ADDENDUM NO. 2

FORT THOMAS TREATMENT PLANT BASIN IMPROVEMENTS

NORTHERN KENTUCKY WATER DISTRICT

February 19, 2015

SHEET
01D107

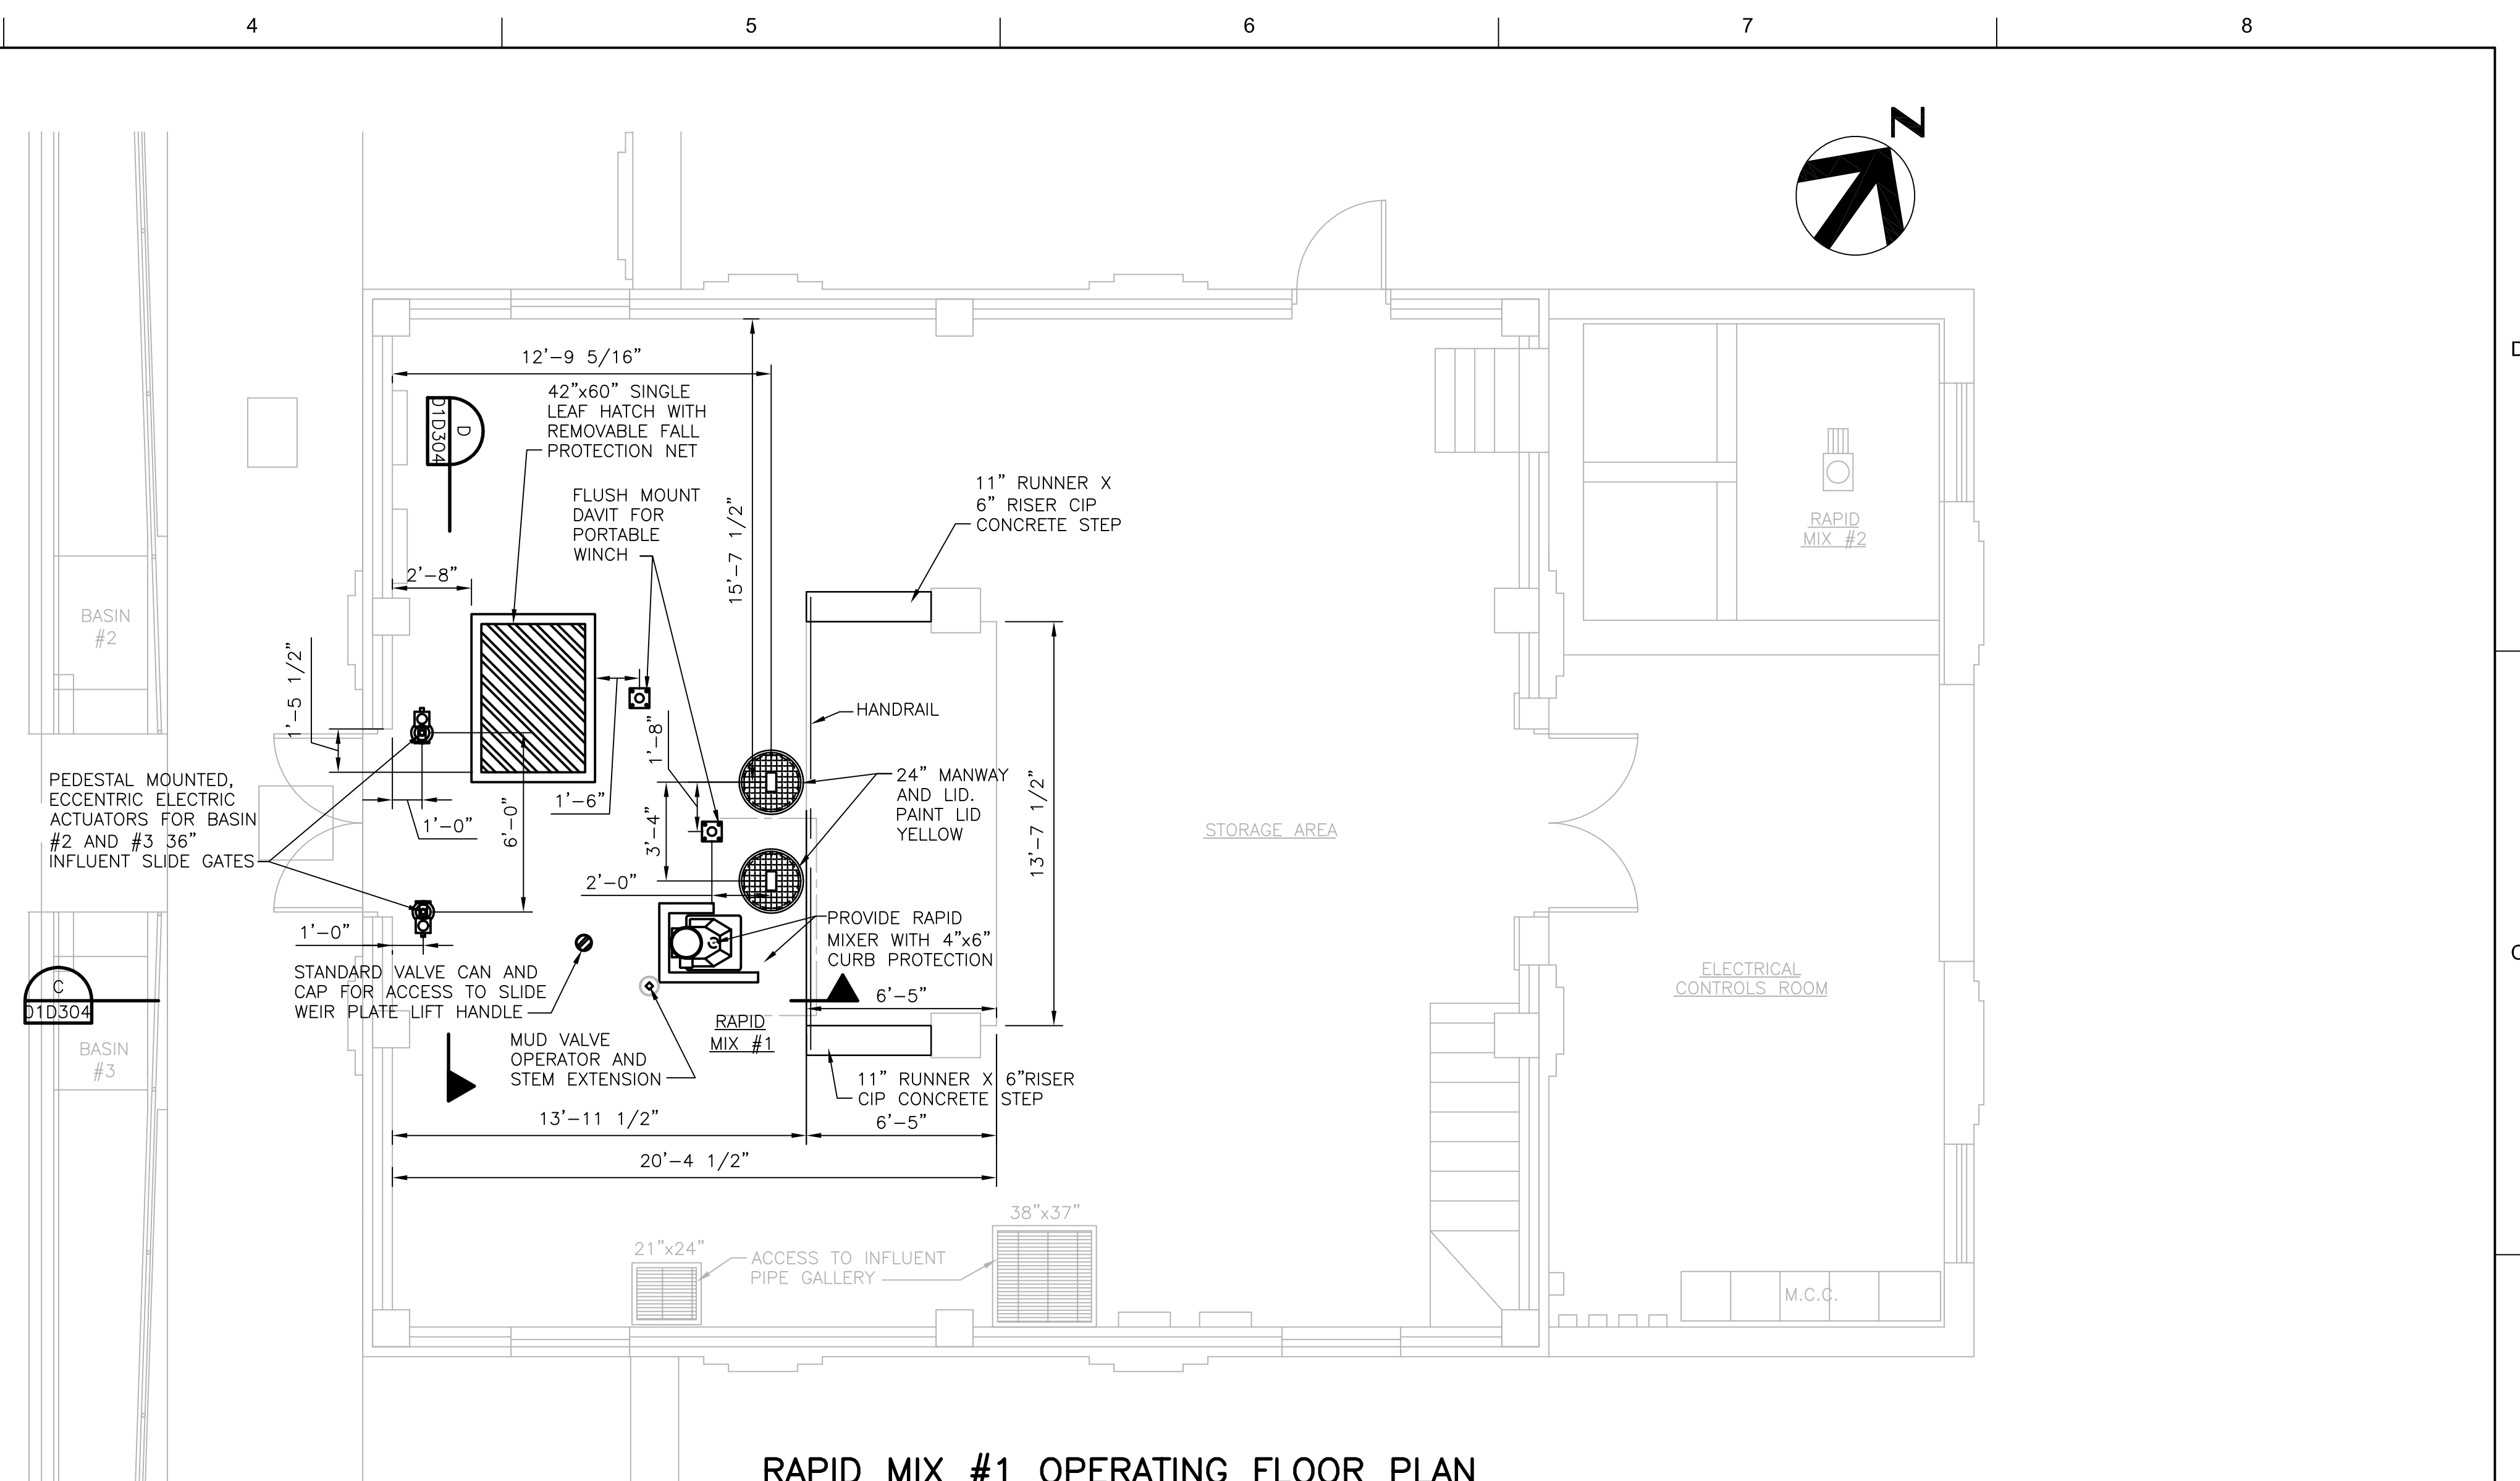
Item No. AD 2-8: Drawing 01D107 - Rapid Mix #1 (Upper and Lower) Floor

Replace Sheet 01D107 with the revised Sheet 01D107 (attached). The revised sheet depicts changes in hatch size and orientation of the Rapid Mix #1 access hatch.

All notes indicating the size of the proposed access hatch to the Rapid Mix Basin #1 as 30"x60" shall be modified to read a hatch dimension of 42"x60" and the hatch shall be reoriented to match the revised positioning as indicated on the revised Sheet 01D107 (attached).
